IMPORTANT SAFETY RECALL NOTICE

Gillig Campaign ID Number: 17V-156

Wiper Arm Inspection and Replacement Procedures

Version Identification – Wiper Arm Mounting Castings

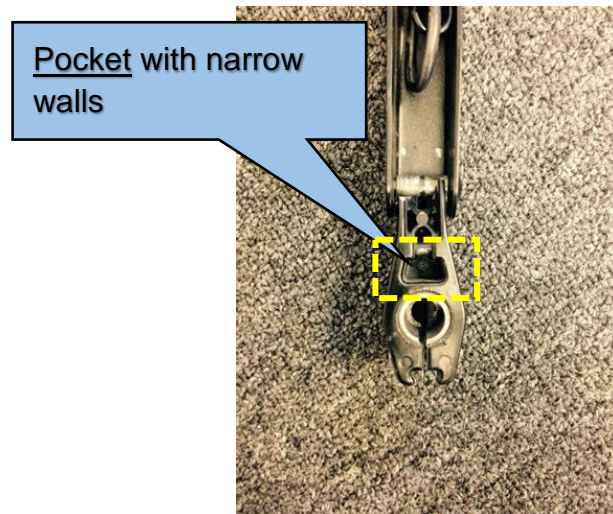
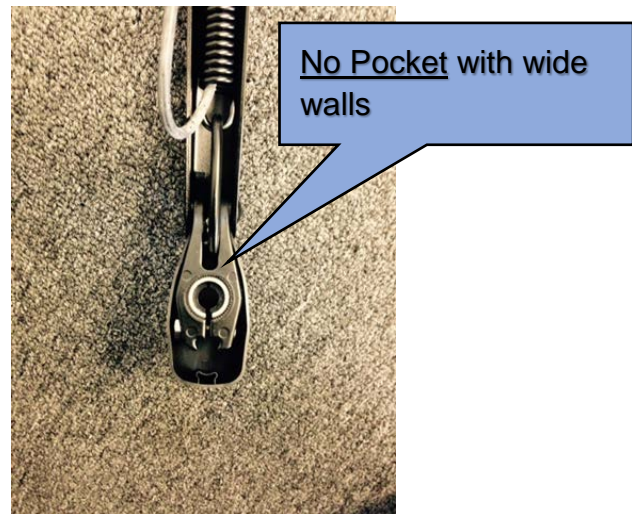
What The Issue Is: ***Certain Sprague Devices brand wiper arms (Gillig Part No. 53-47677V002, Version 1) may develop cracks in the mount casting that attaches them to the wiper motors. In some cases, the arms may bend or detach from the vehicle.***

1. Pull the wiper blade away from the windshield into the off-glass position.
2. Inspect the wiper arm mounting casting as shown below, noting the construction of the mounting casting.
3. The wiper arms being recalled (*Version 1*) can be identified by the pocket in the center of the arm and the thin wall adjacent to the pocket. See picture below.
4. Please record the number of Version 1 wiper arms identified in your inspections and submit a request for this quantity of free recall replacement parts from Gillig.

Upon reception of the *Version 2* replacement parts, please replace all *Version 1* wiper arms per the instructions in the next section.
